# Access Compliance Report Public Rights-of-Way (Curb Ramps)

Intersection ID: 15023	Main Street: FAIRWOOD_AV	Cross Street: S_TRYON_ST	Location: S
ADA ID: DD114D2277CD	Ramp Type: PerpDiag	Initial Pass/Fail: Fail	Overall Compliance: No Severity Score: 36.25

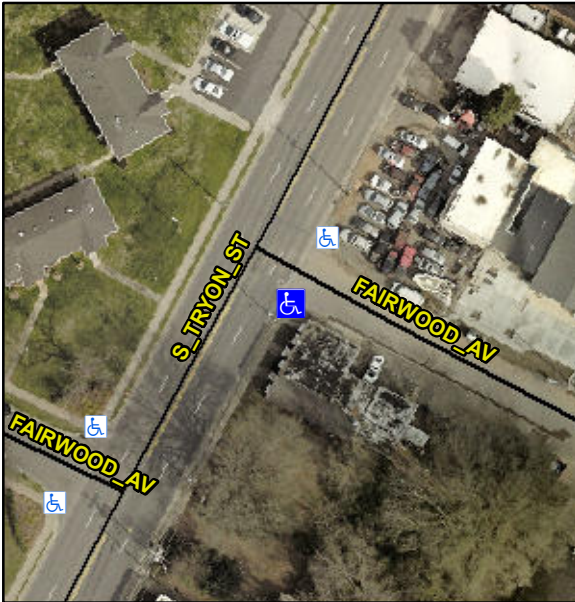
**Not Found, R304.5.1, R304.5.3**

Compliance	Description	Data	Compliance	Description	Data
N/A	Ramp Length (in)	72.0	Yes	Ramp Slope (%)	6.7
No	Ramp Width (in)	30.0	No	Ramp XSlope (%)	4.0
N/A	Flare Type LT	N/A	N/A	Flare Type RT	N/A
N/A	Flare Slope LT (%)	N/A	N/A	Flare Slope RT (%)	N/A
N/A	Flare Traversable LT?	N/A	N/A	Flare Traversable RT?	N/A
N/A	Landing Length (in)	N/A	N/A	DWS Provided?	N/A
N/A	Landing Width (in)	N/A	N/A	DWS Contrast?	N/A
N/A	Landing Slope (%)	N/A	N/A	DWS Length (in)	N/A
N/A	Landing X Slope (%)	N/A	N/A	DWS Full Width?	N/A
N/A	Landing Curb? (Y/N)	N/A	N/A	DWS Offset (in)	N/A
N/A	Shared Landing?	N/A			
N/A	Gutter Ponding?	N/A	N/A	Gutter Slope (%)	N/A
N/A	Gutter Lip Ht (in)	N/A	N/A	Gutter X Slope (%)	N/A
N/A	Painted X Walk1?	No	N/A	Painted X Walk2?	No
	X Walk 1 Direction	To NE		X Walk 2 Direction	To NW
N/A	X Walk 1 Width (in)	N/A	N/A	X Walk 2 Width (in)	N/A
	X Walk 1 Slope (%)	4.5		X Walk 2 Slope (%)	1.8
	X Walk 1 X Slope (%)	1.9		X Walk 2 X Slope (%)	5.8

Possible Solutions:  
**Remove & Replace Curb Ramp With Two New Directional Ramps or Equivalent.**
